# COMMUNITY DEVELOPMENT DEPARTMENT REPORT

HEARING DATE: 11/7/2024  
TO: Planning & Zoning Commission  
FROM: Linda Ritter, Associate Planner  
208-884-5533  
lritter@meridiancity.org  
APPLICANT: Laren Bailey, Conger Group  
SUBJECT: H-2024-0023  
Summerlin West Subdivision AZ, PP  
LOCATION: Located in the NW ¼ of the SW ¼ of Section 5, Township 2N, Range 1E, parcels: R5147110200, R5147110324, R5147110342 and S1405315235

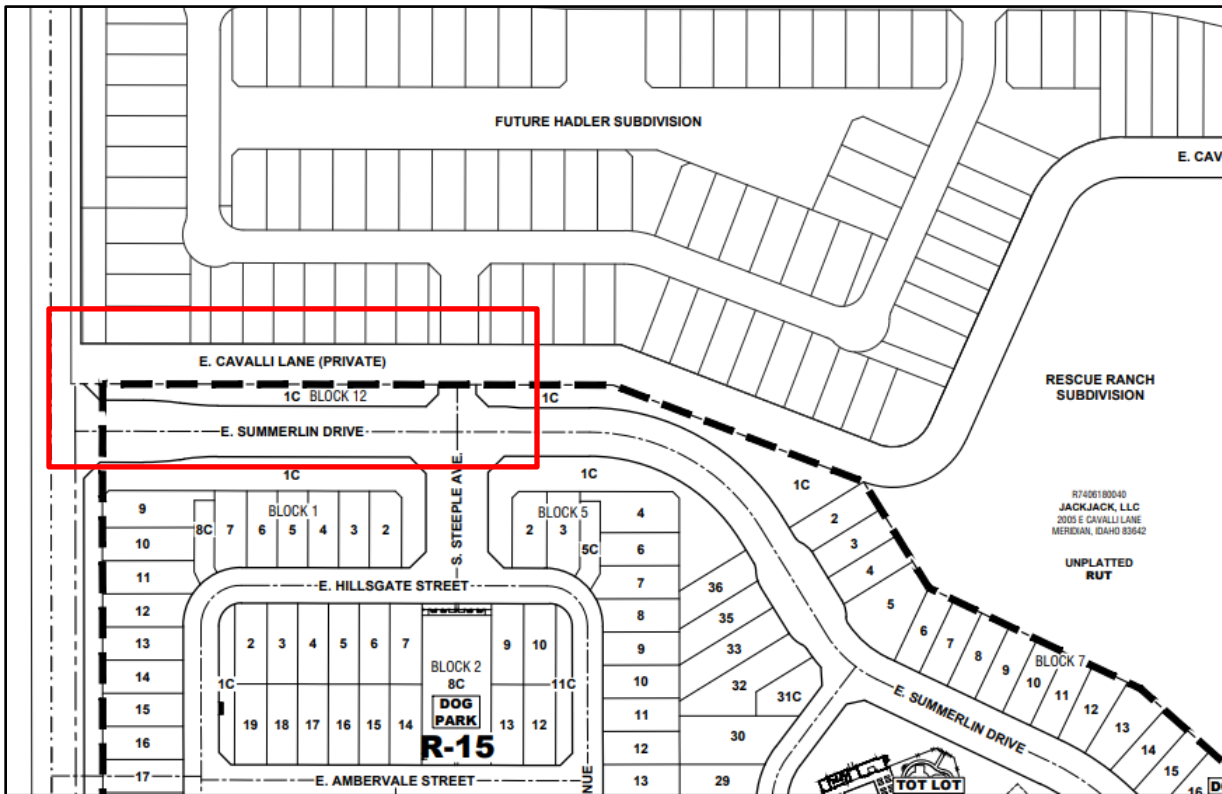
*Staff has concerns regarding access management and potential impacts due to the close proximity of the private road (E. Cavalli Lane) to the proposed public road (Summerlin Drive). Staff feels the applicant and the adjacent property owner should coordinate to develop a shared access solution. A shared access point could potentially reduce traffic congestion and simplify entry/exit points, particularly for larger developments and not leave fifty (50) feet of undeveloped land. See image below.*

# H. Block Length

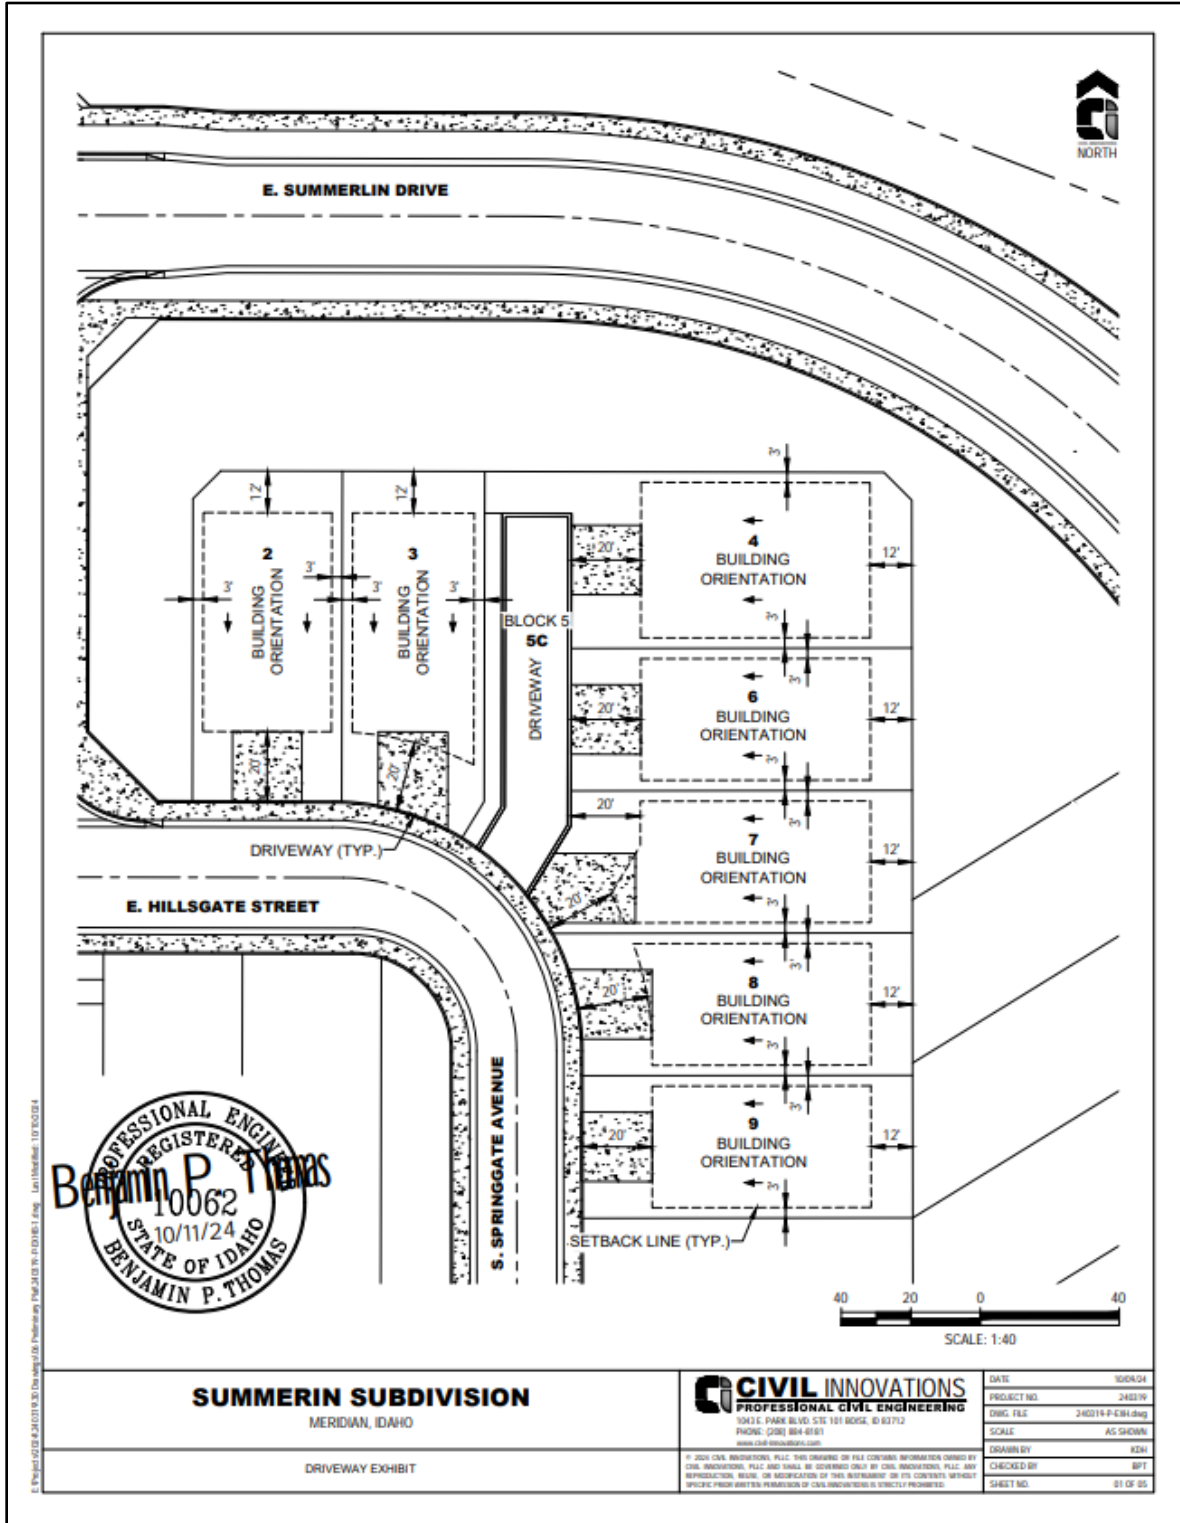
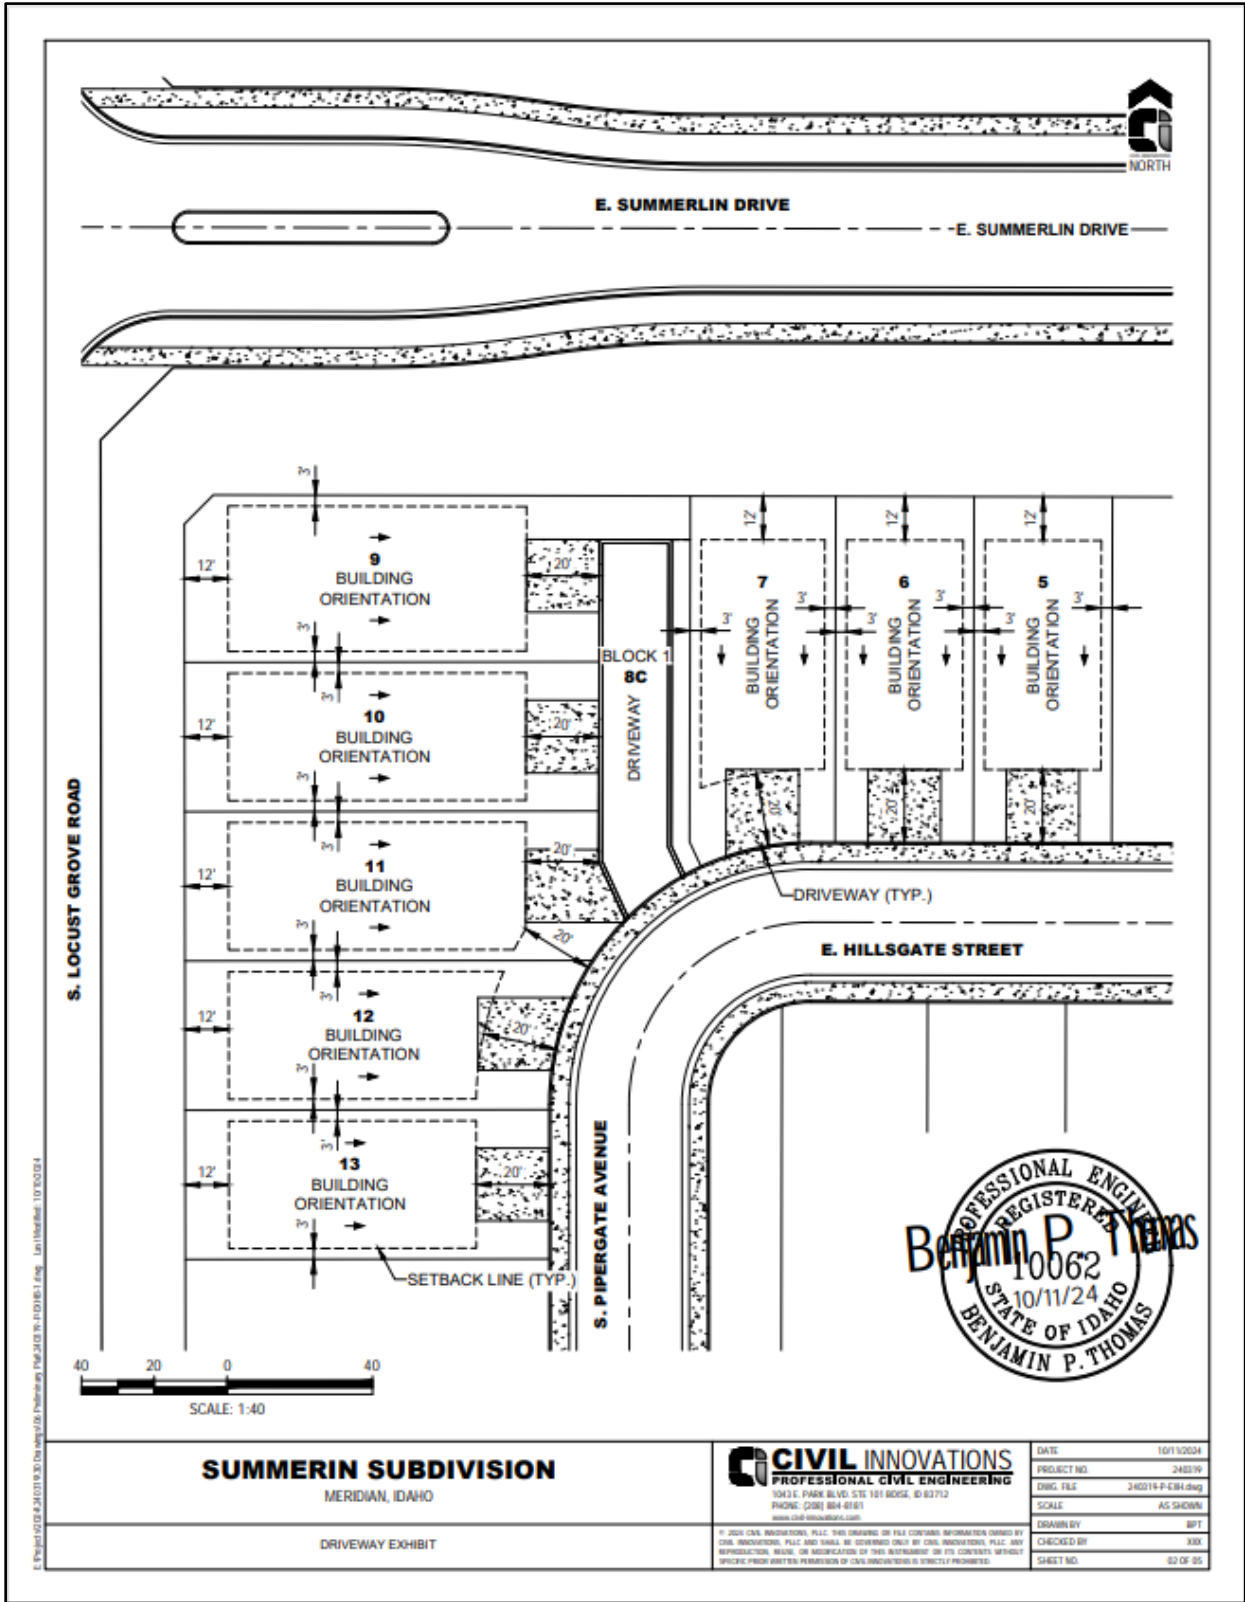
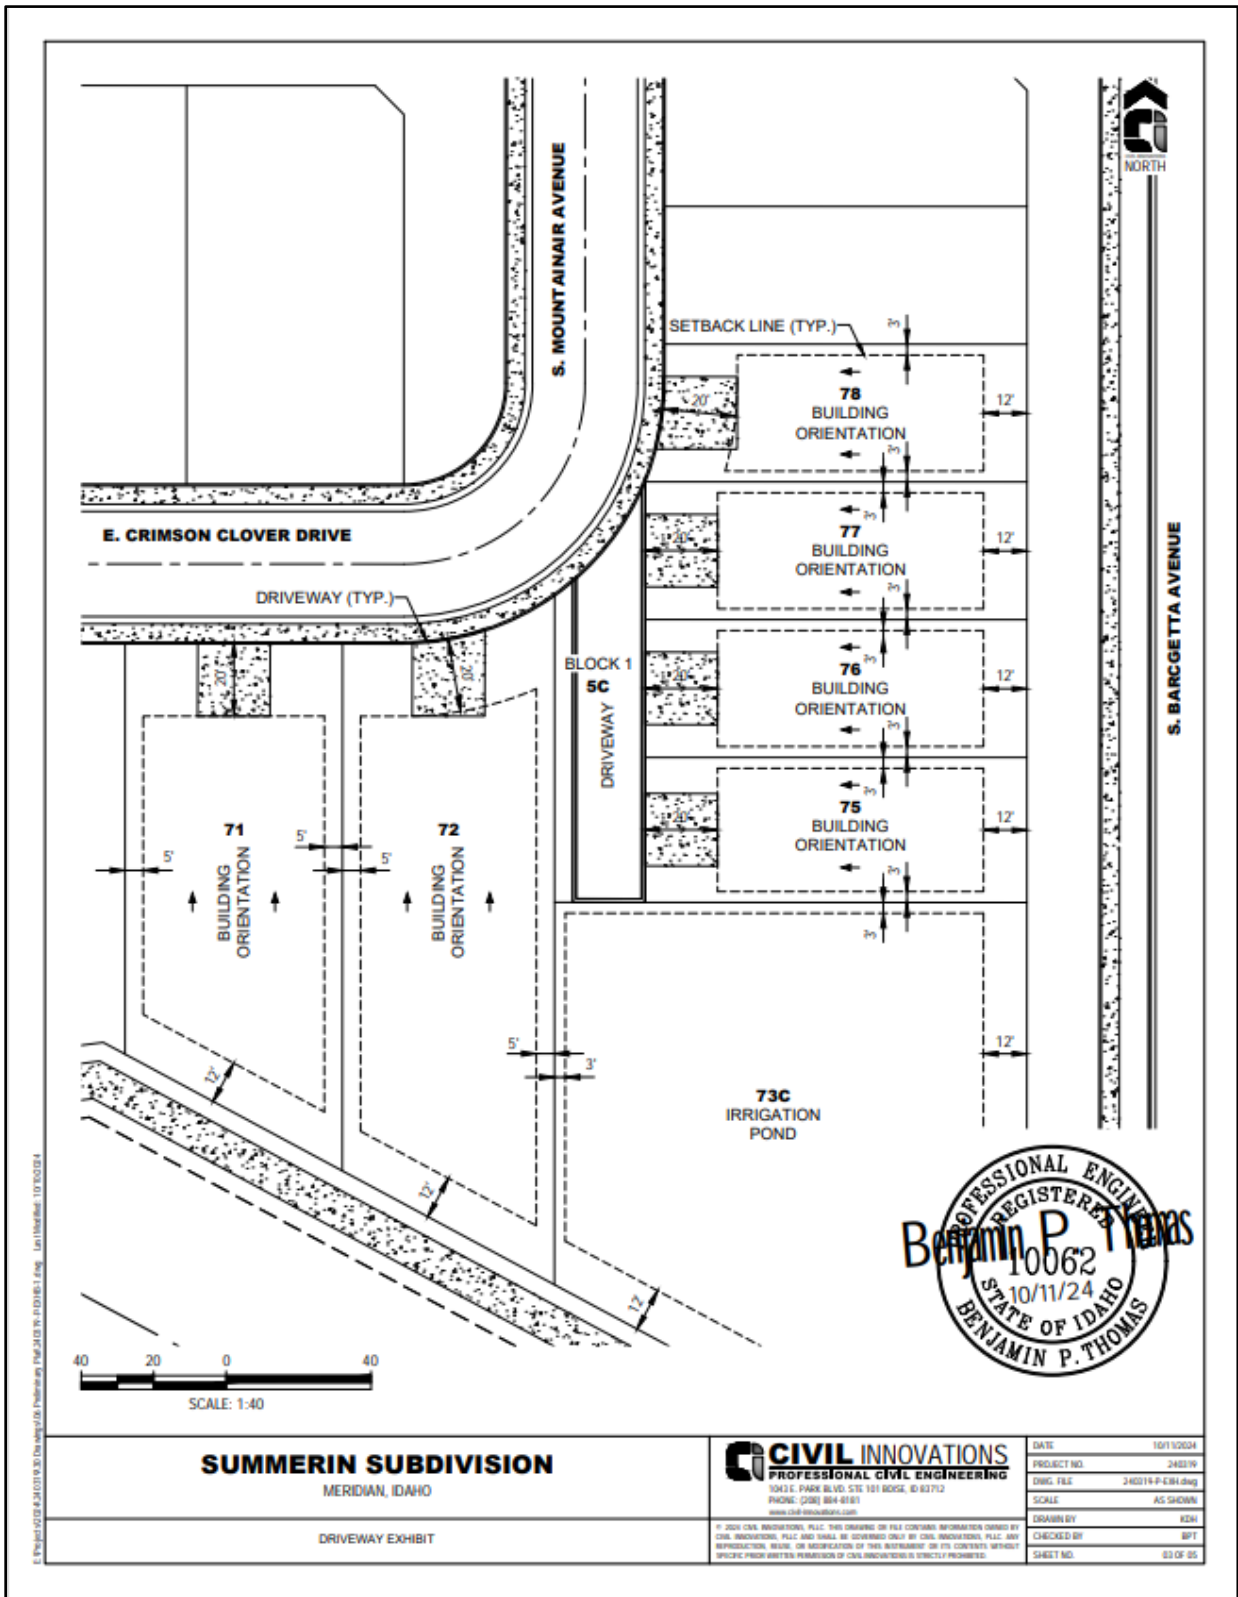
*It appears that several blocks exceed 750 feet, but the applicant has provided a pedestrian connection as allowed by UDC 11-6C-3. However, E. Crimson Clover Drive exceeds the maximum block length of 1,200 feet by 665 feet (1,865 feet). The applicant has requested a waiver from Council for exceeded block length.*

# I. Common Driveways

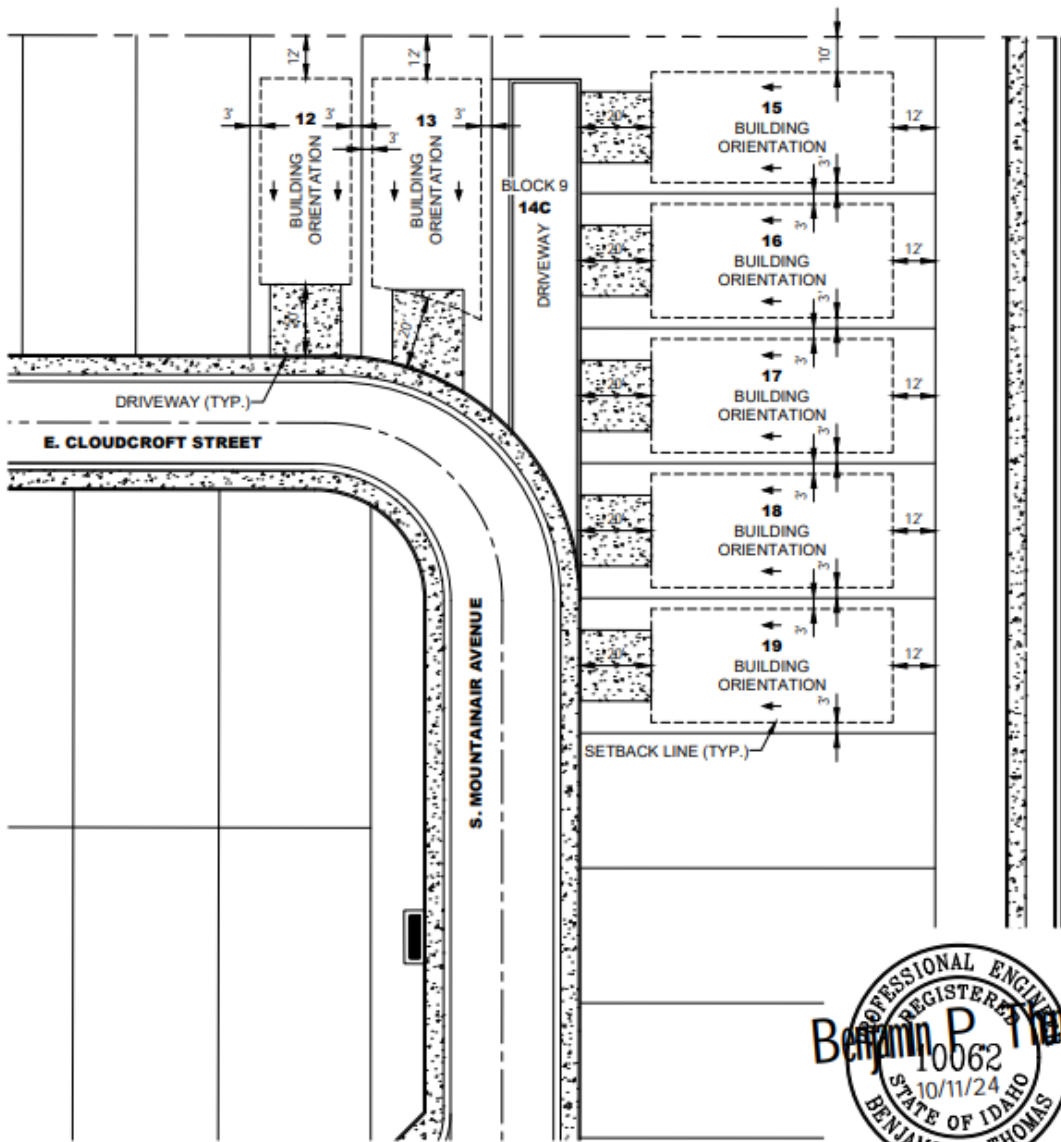
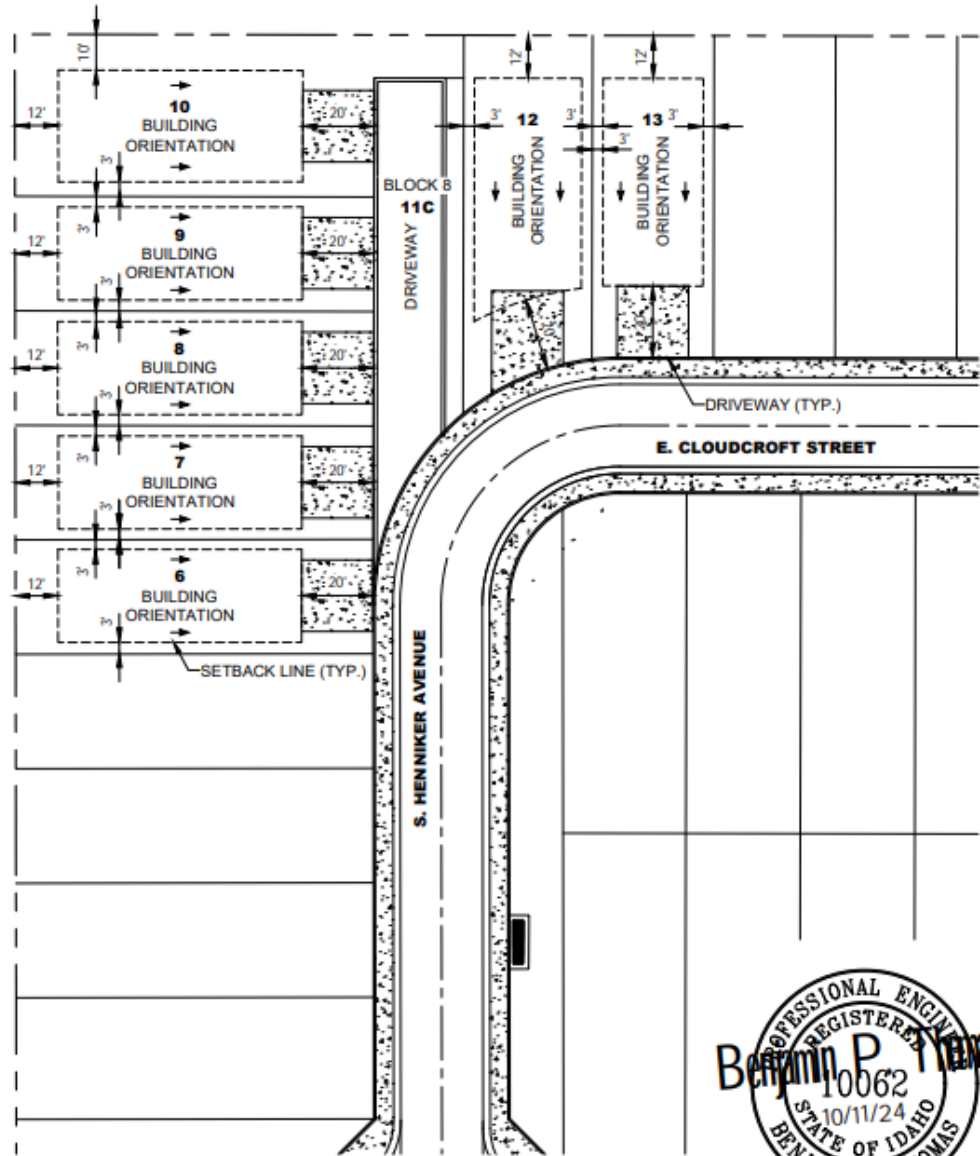
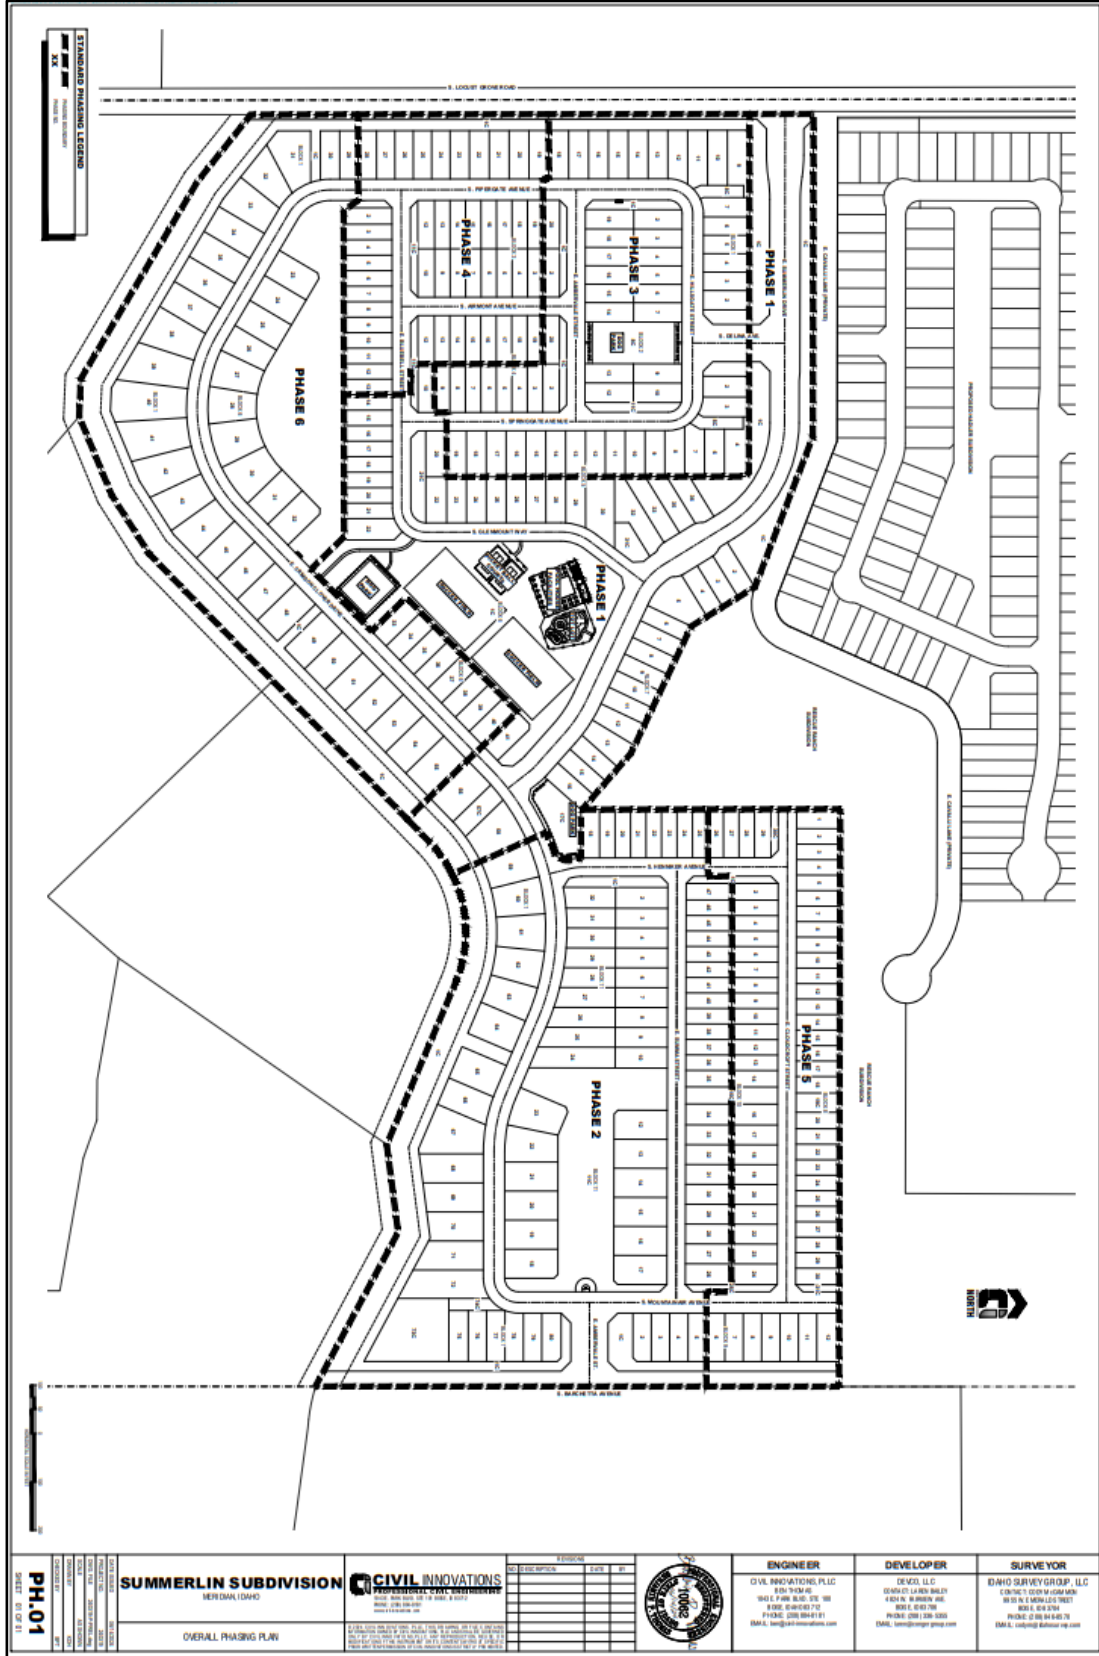
Five (5) common driveways are proposed with this subdivision. The applicant has provided common drive exhibits which demonstrate no more than three (3) units are served whereas a maximum of 4 units are allowed. The common driveway meets the minimum width of twenty (20) feet and does not exceed the maximum length of one hundred and fifty (150) feet. Solid fencing adjacent to common driveways is prohibited, unless separated by a minimum five (5) foot wide landscaped buffer.

*The applicant is proposing five (5) common driveways that meet the dimensional requirements as outlined in the UDC.*

13. All common driveways shall meet the requirements of 11-6C-2-D including a perpetual ingress/egress easement being filed with the Ada County Recorder, which shall include a requirement for maintenance of a paved surface capable of supporting fire vehicles and equipment.
